**PB# 87-38**

**Grove Homes**

**SUBJECT: Grove Homes Store/Office Site Plan**  
**New Windsor Planning Board (87-38)**

PROJECT NAME: Grove Homes Retail Stores/Offices  
PROJECT LOCATION: Route 94 (North Side)  
NW#: 87-38  
28 October 1987

### SITE PLAN

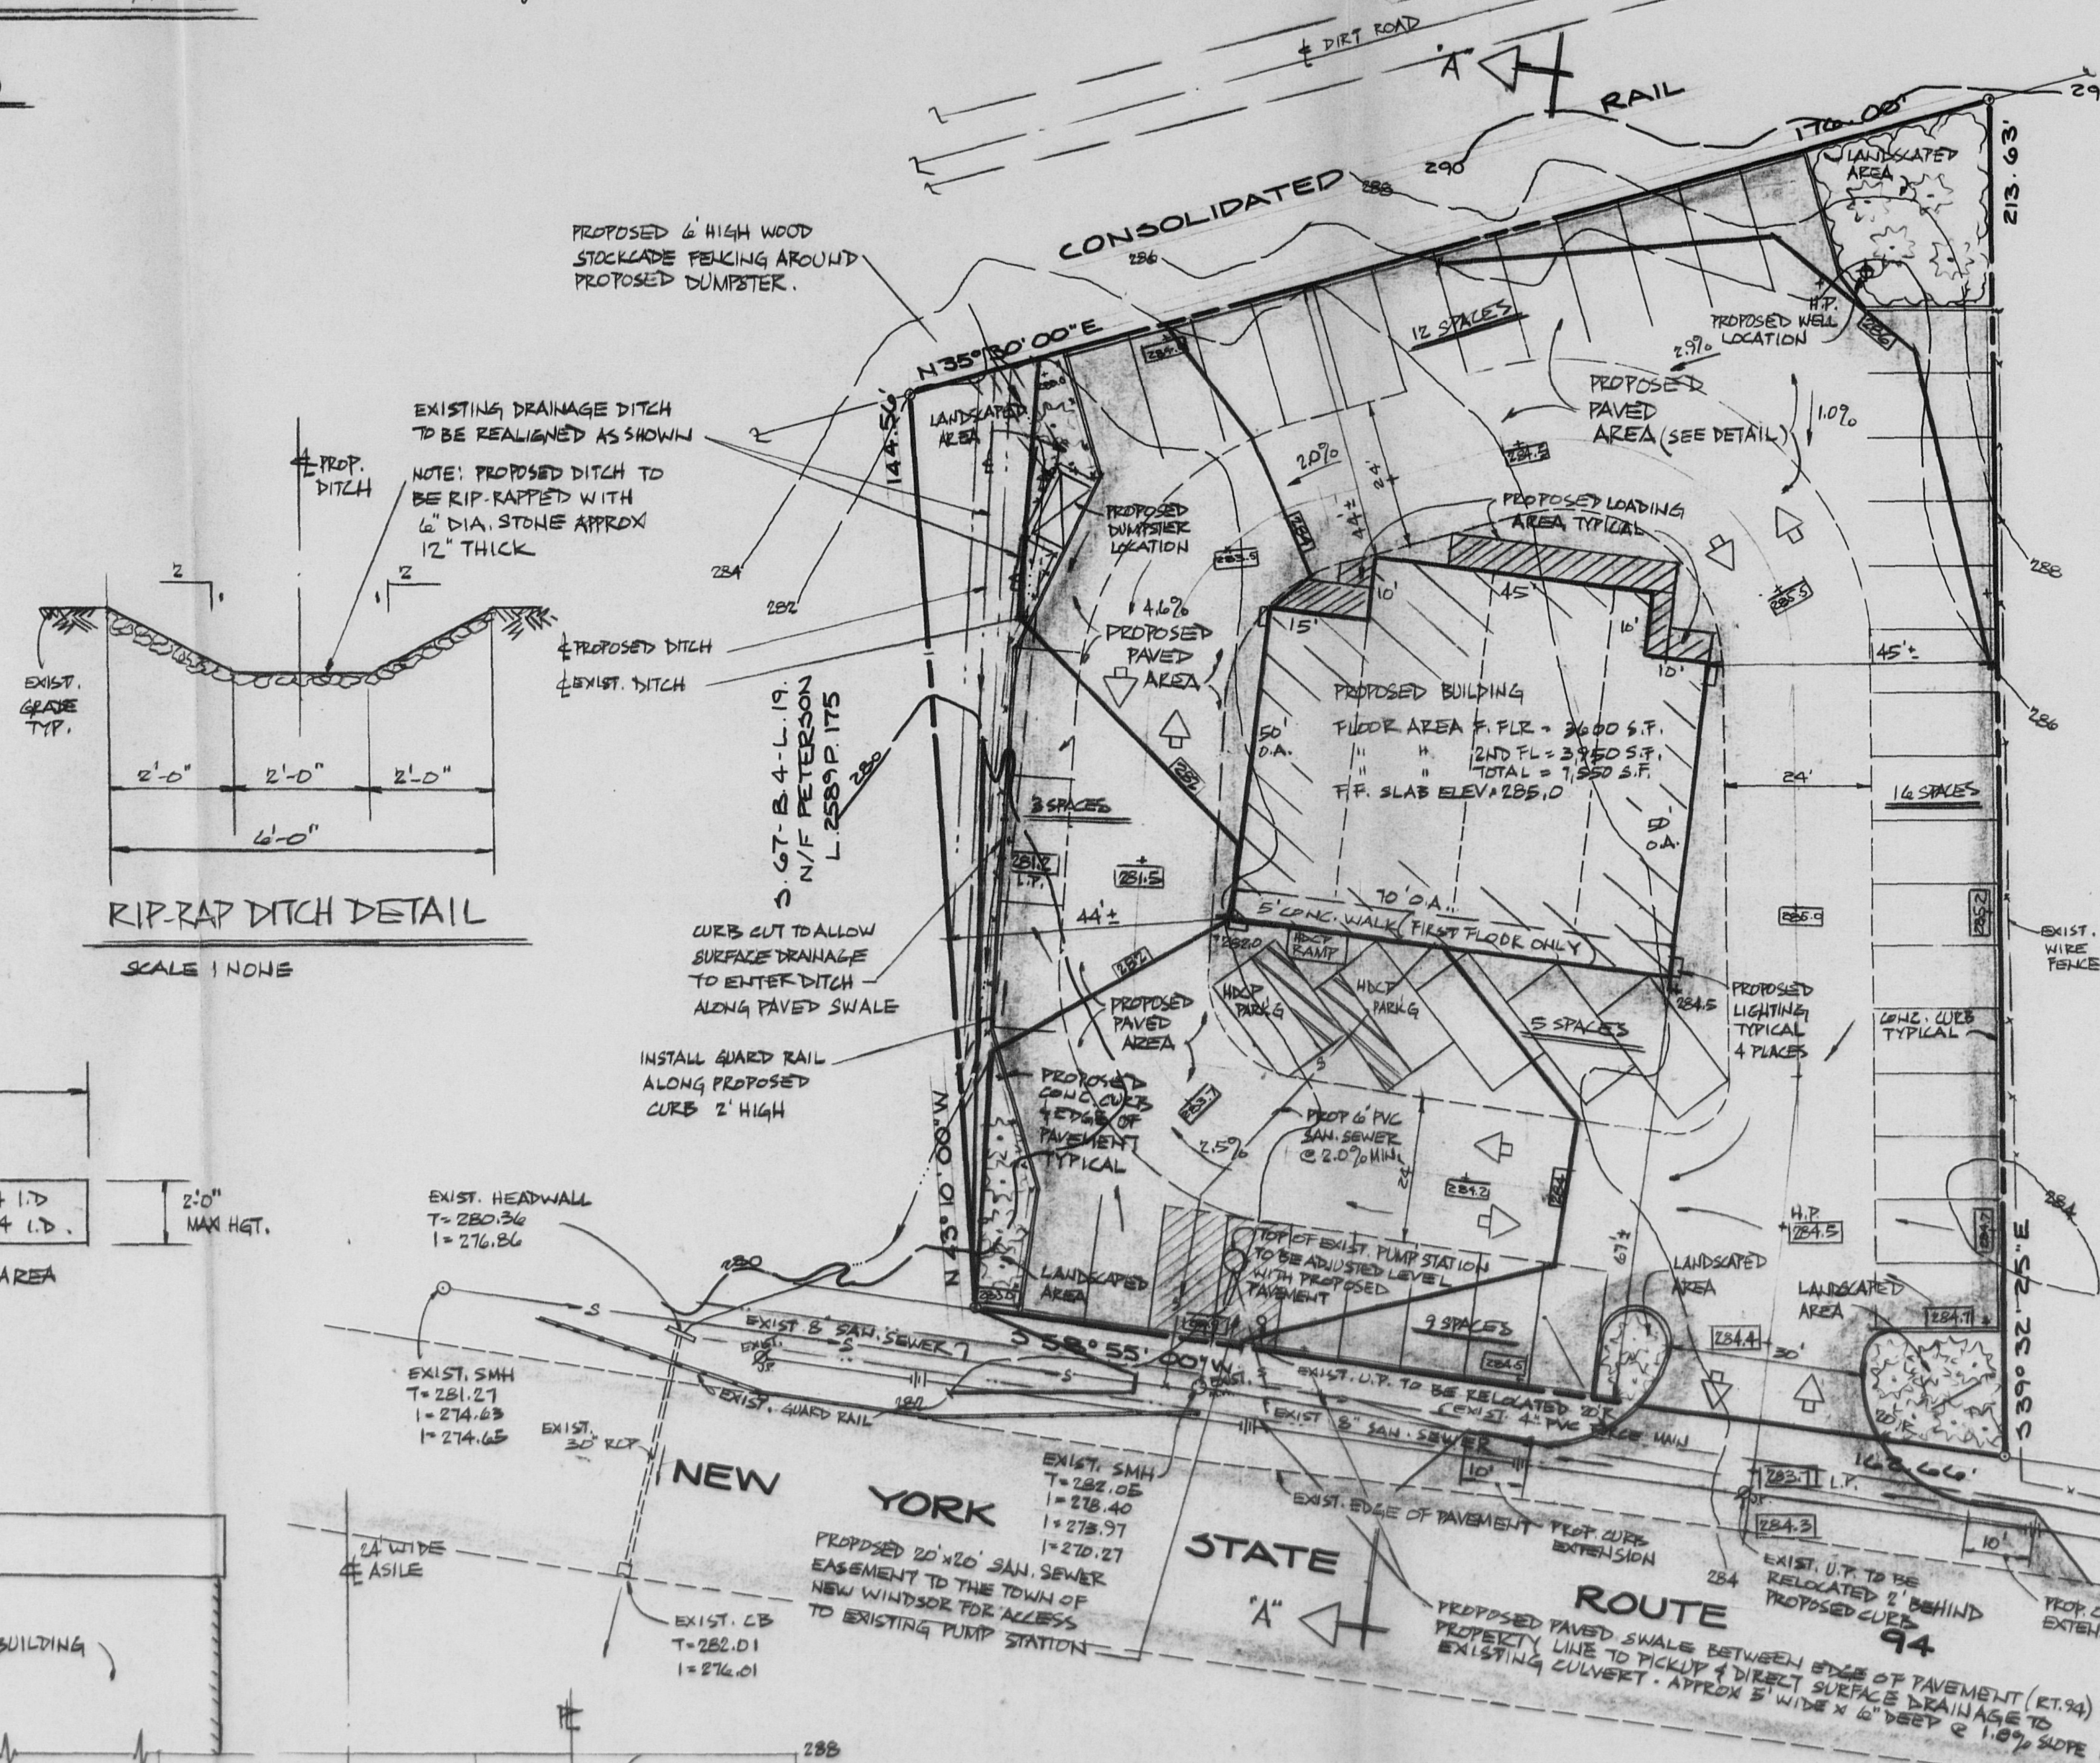
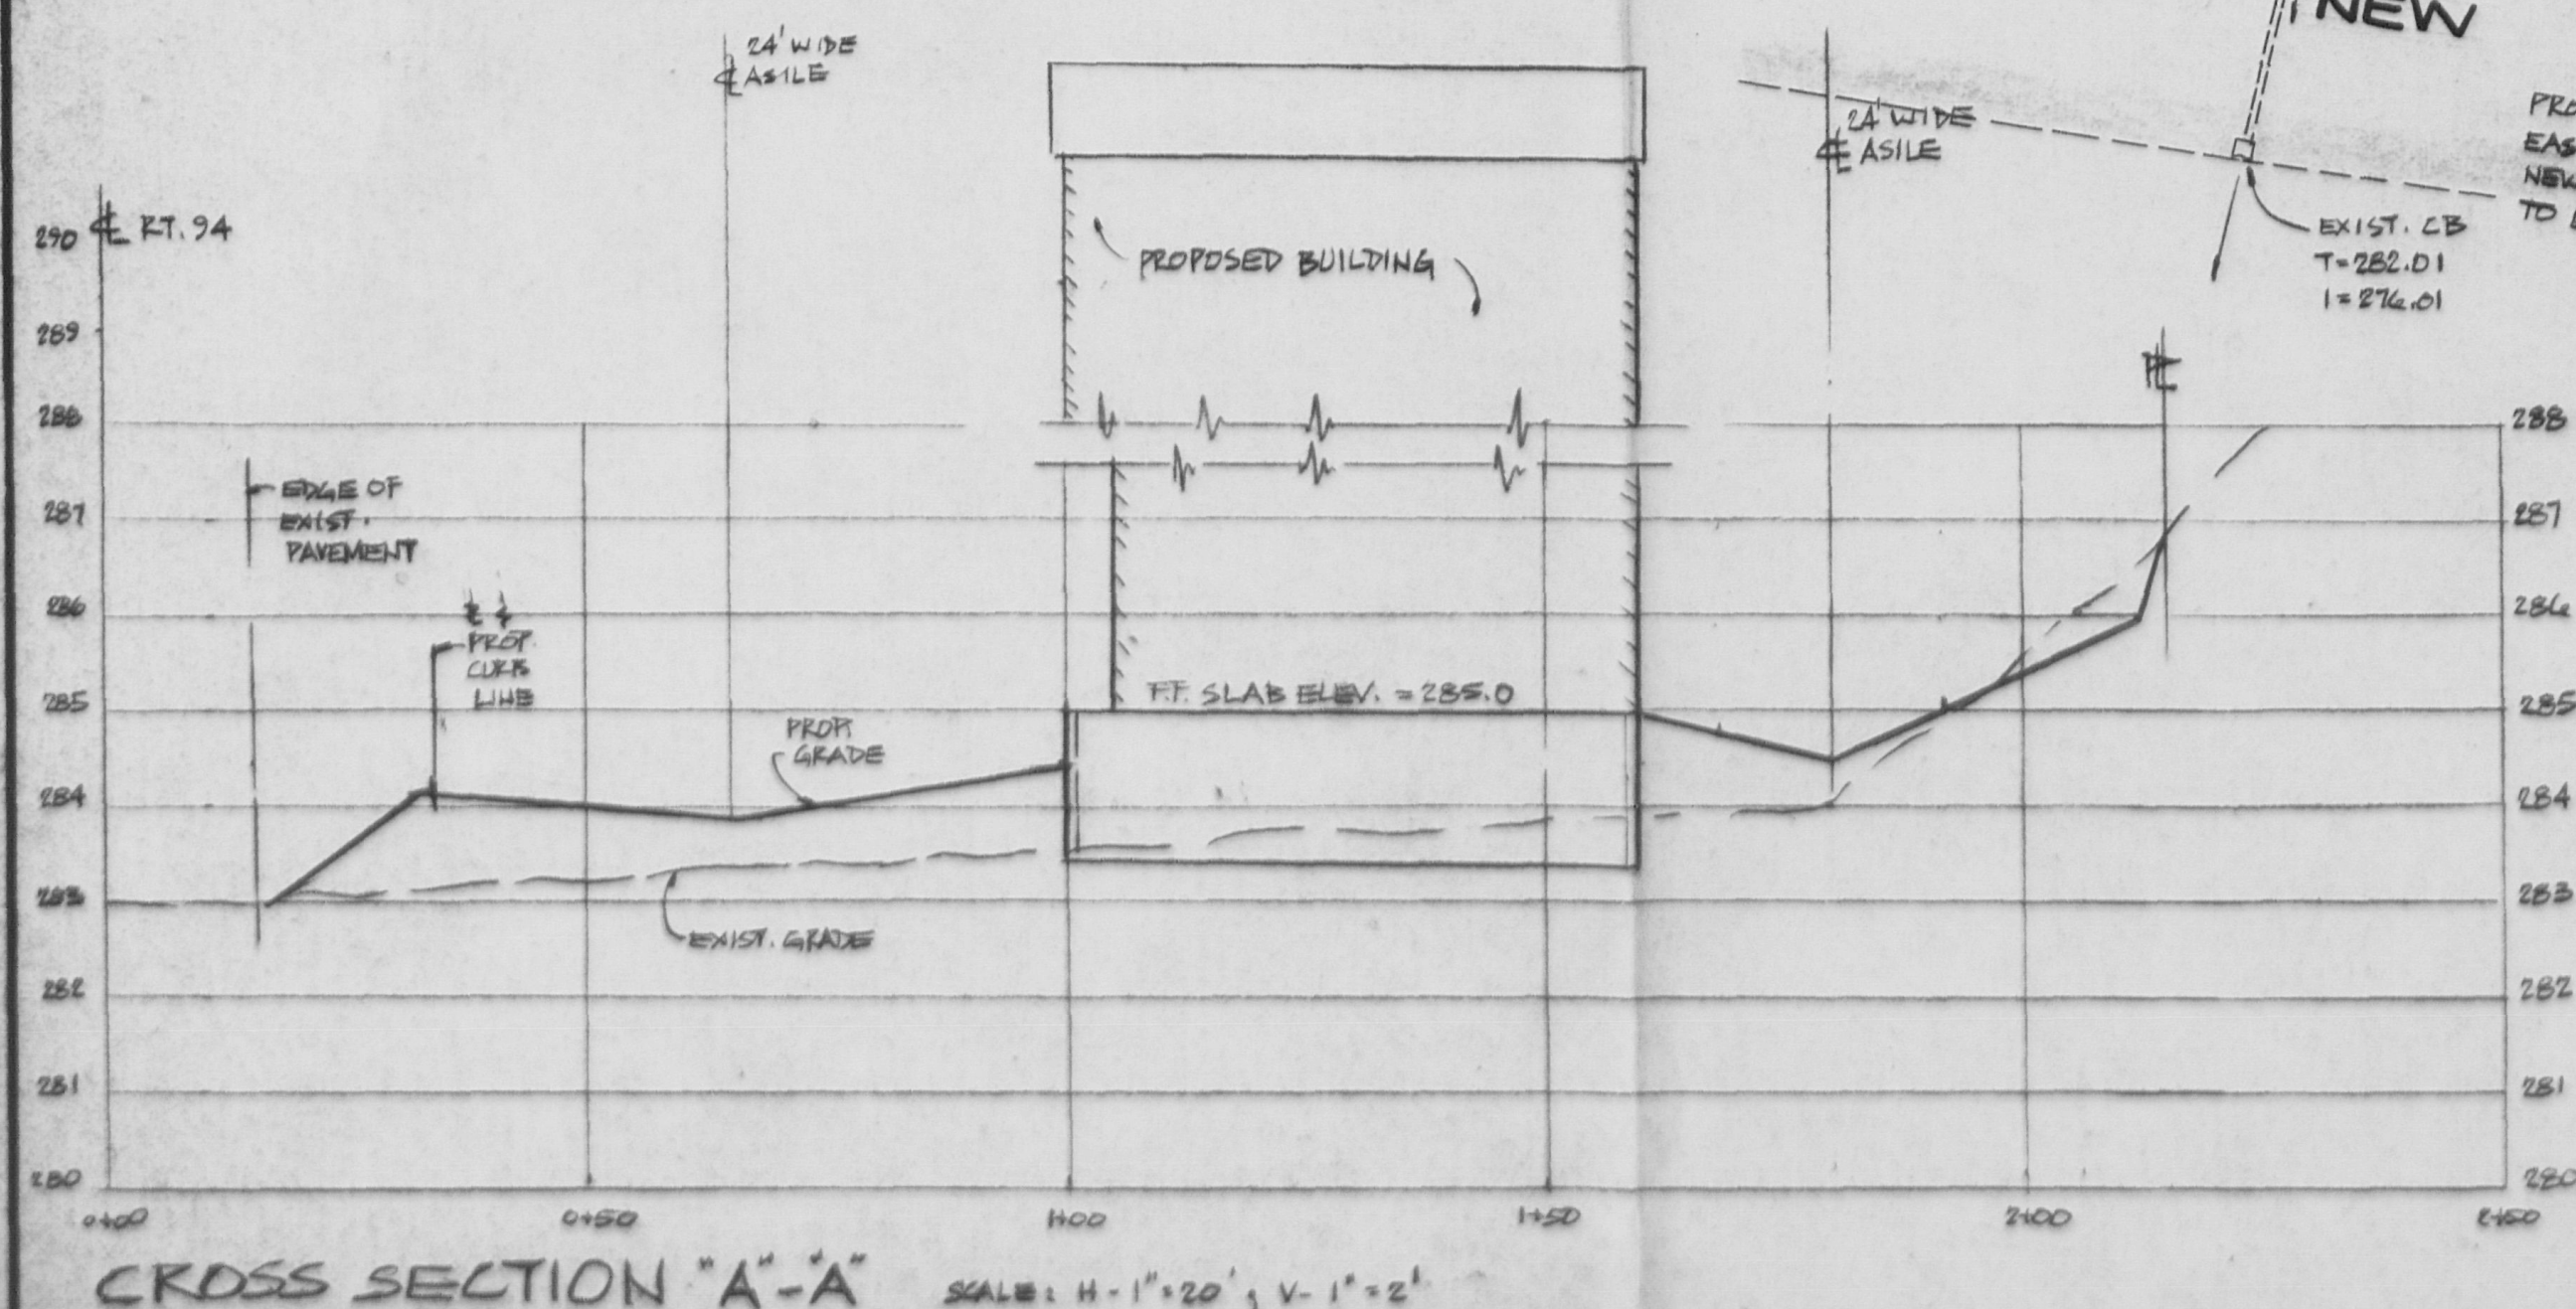
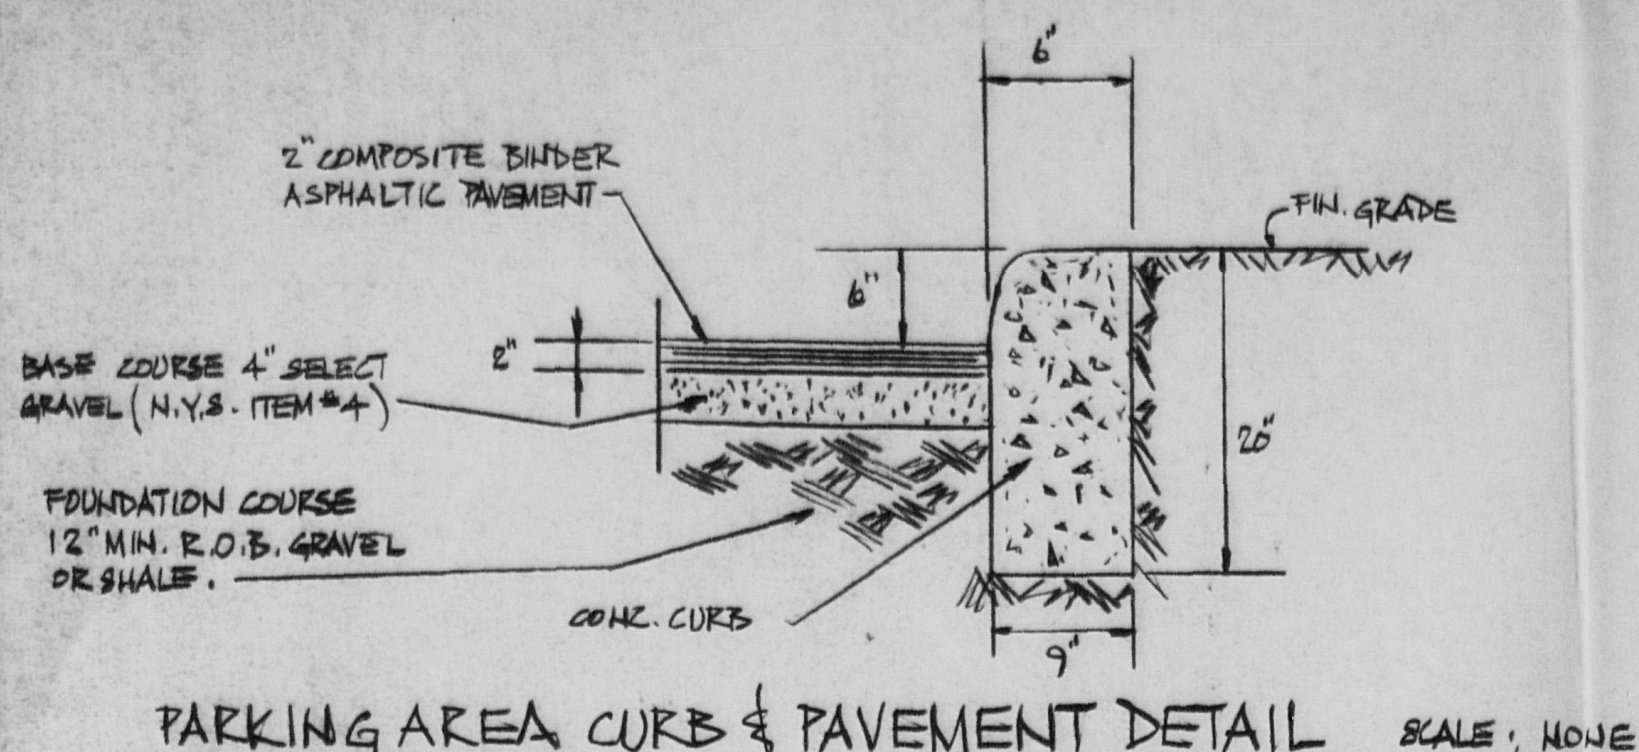
4. It appears that the applicant has provided six (6) parking spaces in the front of the building, rather than five (5) as shown on the approved plan. This has resulted in an encroachment of the parking spaces into the westerly circulation lane. This should be corrected.

5. At the front of the site where the Town Pump Station is located, it was indicated that the pump station would be adjusted level with the proposed pavement, such modifications subject to Town approval. The pump station has not been modified and no protection exists for the pump station from vehicular damage. The developer should be required to install bollards and/or guide rail in a manner acceptable to the Town Sewer Department. Further, it should be noted that John Egitto has advised me that the station is now leaking through the wall joints, which indicates that it may have been disturbed during the construction work. Repair work should be made to the pump station to the satisfaction of the Town Sewer Department.

6. In addition to the previous comment, it should be noted that the utility pole indicated to be relocated on the plan, remains as an encroachment to the adjoining parking spaces. This pole and the electrical service to the pump station, including control panel, should be relocated, to the satisfaction of the Town Sewer Department.

7. The Applicant has not installed a handicapped ramp as indicated on the plans. Further, the finished pavement grading is such that there is not a smooth transition from the handicapped parking spaces to the front building sidewalk. Either the pavement must be changed, the ramp built or the handicapped spaces relocated in a manner in which the handicapped access route would meet State code.

8. The sidewalk on the front of the building is nearly flush for most areas. Since the developer did not construct a standard raised sidewalk/curb section, no wheel stops exist to stop vehicles from causing damage to the building face. As such, it is recommended that the developer install concrete wheel stops for the spaces in front of the building.

9. The existing drainage ditch along the west side of the property has been relocated near the rear of the site. It appears that during the construction of the overall site, siltation has occurred which has somewhat filled the swale. It is my recommendation that the developer be asked to clean out the swale from the rear of the site to the existing headwall on Route 94, to promote better flow and avoid a flooding problem on the adjoining property. A portion of this swale appears to flow through the adjoining property; therefore, they should get permission from the adjoining property owner before doing that portion of the work.

1. The Applicant has submitted a Site Plan for review for the construction of a two (2) story structure for retail store and office use. The Plan was reviewed previously at the 9 September 1987 and 14 October 1987 Planning Board Meetings.

2. The Plan has been revised to indicate that the parking area will be paved per the detail on the Plan and a rip-rap treatment will be provided for the proposed swale being relocated. The Applicant's Representative should indicate if any other changes have been made to the Plan.

3. My concerns indicated in my comments prepared for the 14 October 1987 meeting with regard to dual direction traffic and size of the loading area remain, and the Board should determine if such items are of their concern prior to approval.

4. A final determination with regard to the easement around the existing sewage pump station should be made. My review of the adequacy of the pump station for truck loadings is not completed at this time.

- a. Is the dual-direction traffic pattern on the site the best layout?
  - b. Will the proposed loading area for the retail stores be sufficient and will trucks making deliveries block the traffic flow?

- c. The proposed sign detail as shown on the plan.
4. Prior to site plan approval, it should be verified if the Town of New Windsor already has an easement for the existing sewage pump station. In addition, it must be determined if the pump station is suitable for placement under a paved area which may be subject to truck loadings. I will coordinate this aspect with the Town Engineering Department.

3. So as to make the Site Plan more complete, the Applicant should add that information required per the Application Package Checklist, bulk not appearing on this Plan. Same to include, at minimum, both tables, approval box, lighting, refuse storage and screening, paving/curb details, proposed signs, etc.

4. The Applicant should indicate on the Plan any easements in favor of the Town of New Windsor for the existing sewage pump station located in the southwestern quadrant of the site.

5. Submittal of this Plan to the New York State Department of Transportation for their review, approval and a Permit is required.
6. The Plan as submitted indicates that the drive off Route 94 will be constructed at a positive +1% slope onto the site. Since no stormwater collection facilities are shown on the Plan, the effect of surface run-off onto Route 94 is questioned.

7. The Plan indicates that an existing 30" culvert crosses Route 94 just west of the property. The path (s) of such drainage should be verified and the relative intensity determined so that any affects of this development (or the lack of same) on drainage flow can be determined.
